PROJECT REFERENCE NO.	SHEET NO.
R-2707C	EC-42/CONST.42
R/W SHEET NO.	
ROADWAY DESIGN ENGINEER	HYDRAULICS ENGINEER

CLEARING AND GRUBBING
EROSION CONTROL FOR
CONSTRUCTION SHEET 42

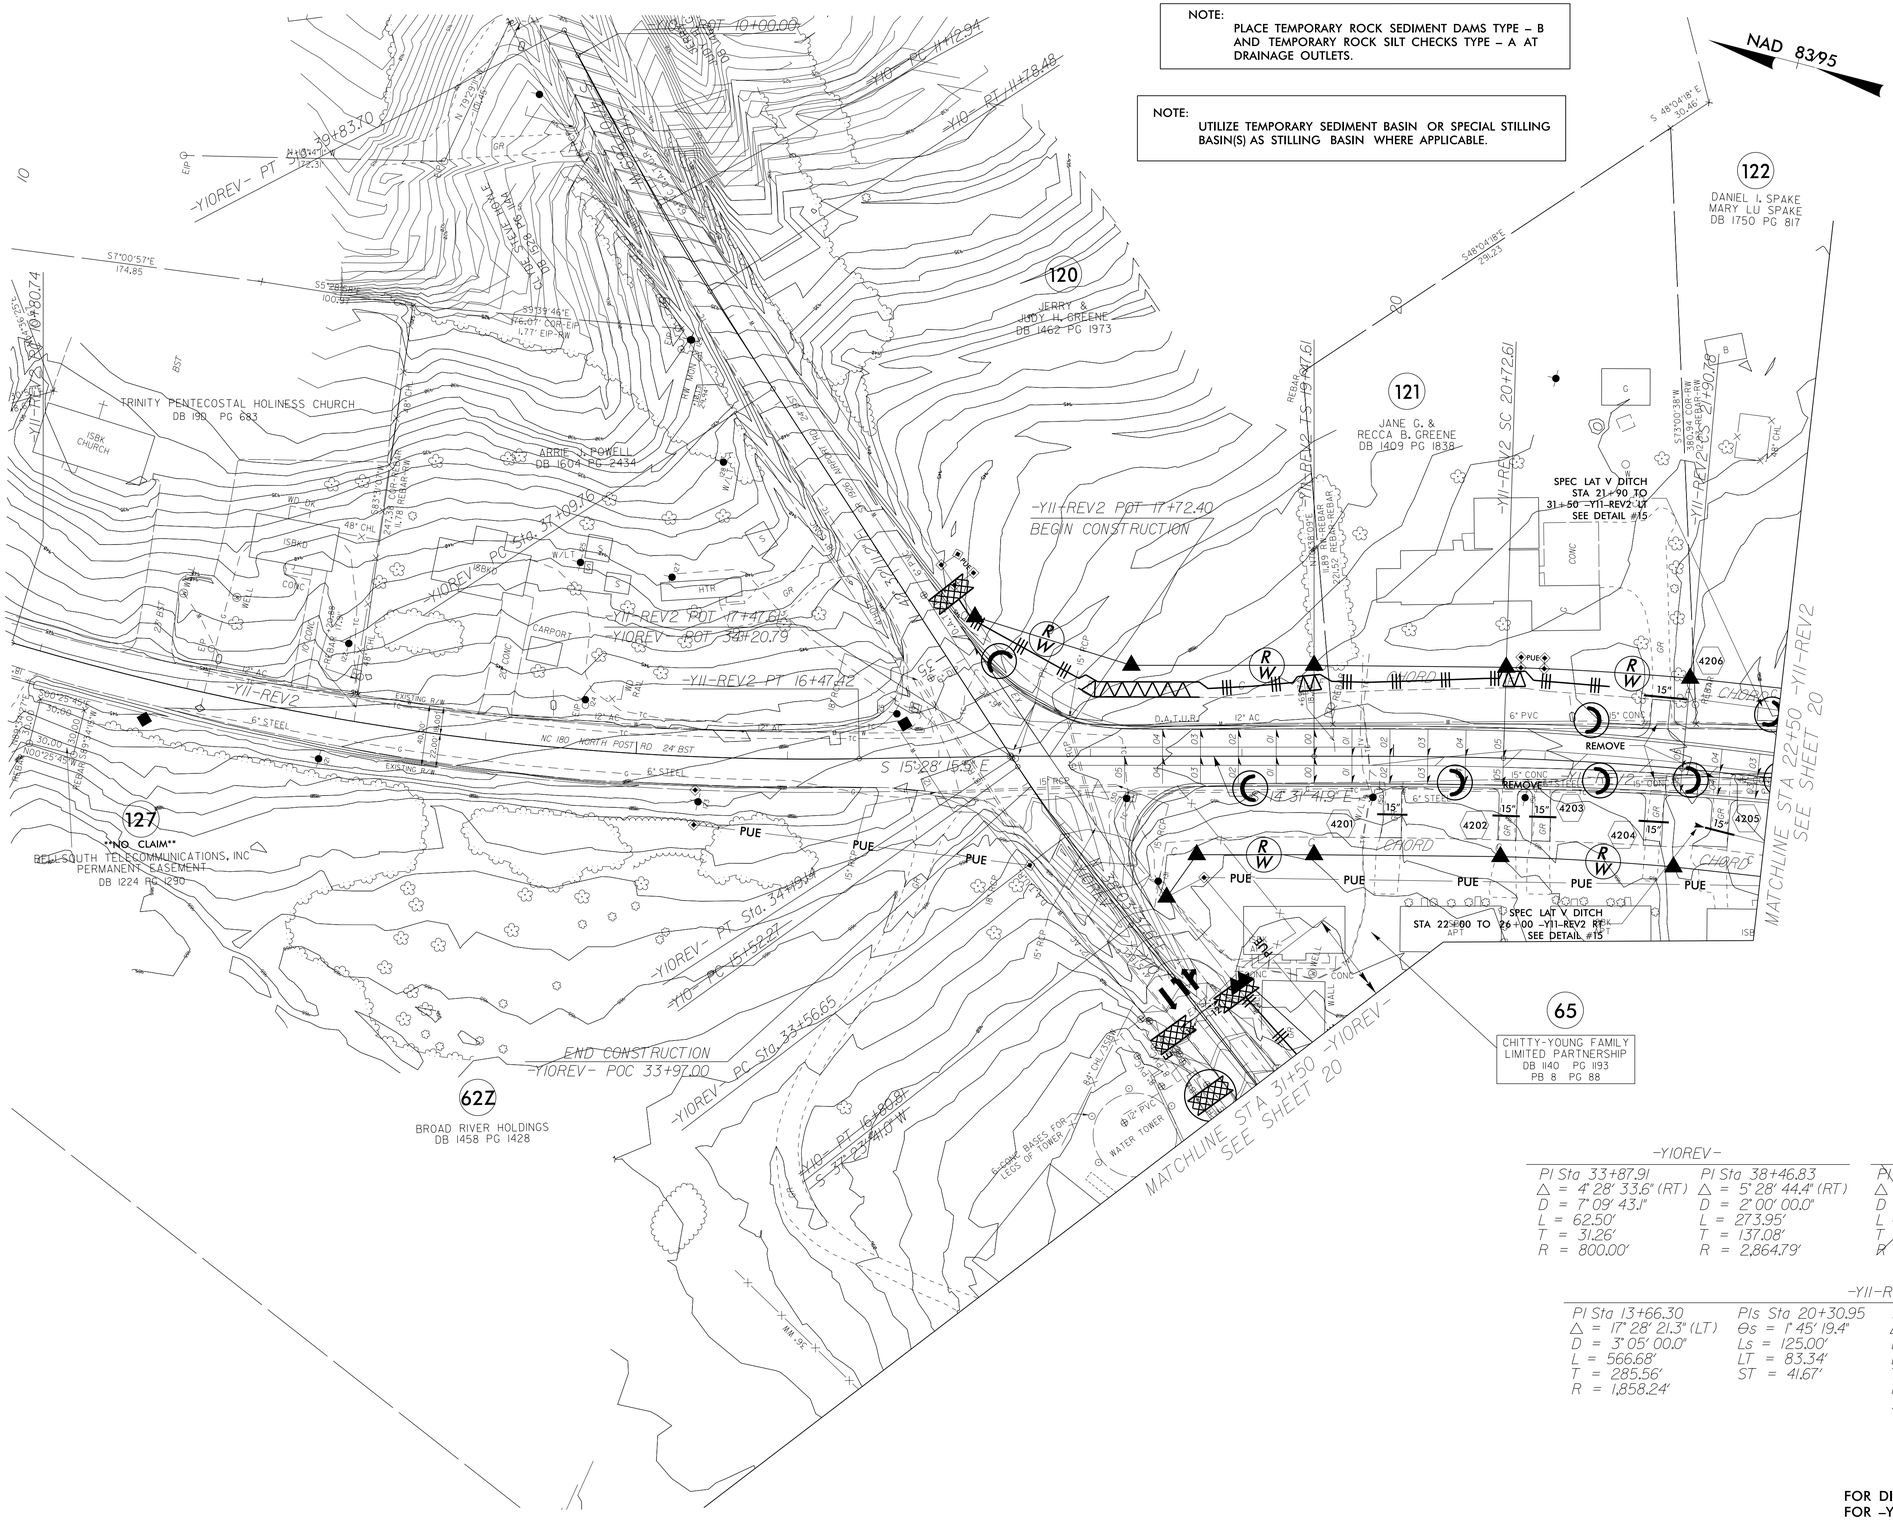
~~-Y10-~~

~~PI Sta 11+45.72~~	~~PI Sta 16+16.58~~
~~Δ = 4° 38' 15.9" (LT)~~	~~Δ = 5° 08' 30.1" (LT)~~
~~D = 7° 00' 00.0"~~	~~D = 4° 00' 00.0"~~
~~L = 86.54'~~	~~L = 128.54'~~
~~T = 43.29'~~	~~T = 64.31'~~
~~R = 818.51'~~	~~R = 1432.39'~~

R/W REVISION ON LET PROJECT 6-22-17 (TEH) – ADDED PARCEL 127 – PARCELS 120, 121 AND 127 – ADDED PUE
R/W REVISION ON LET PROJECT 8-18-17 (TEH) – RELOCATED PARCEL 127 AND ADDED PARCEL 62
R/W REVISION ON LET PROJECT 1-24-18 (DGM) – COMBINED PARCEL 123 AND PARCEL 122 – OWNER CHANGED TO DANIEL I SPAKE, PARCEL 123 REMOVED
CONST.REV.(03/XX/2020)-REMOVED -Y10- ALIGNMENT AND ADDED -Y10REV-.ADDED 2 CLAIMS TO PARCELS 62,65.HN

-Y10REV-

PI Sta 33+87.91	PI Sta 38+46.83
Δ = 4° 28' 33.6" (RT)	Δ = 5° 28' 44.4" (RT)
D = 7° 09' 43.1"	D = 2° 00' 00.0"
L = 62.50'	L = 273.95'
T = 31.26'	T = 137.08'
R = 800.00'	R = 2,864.79'
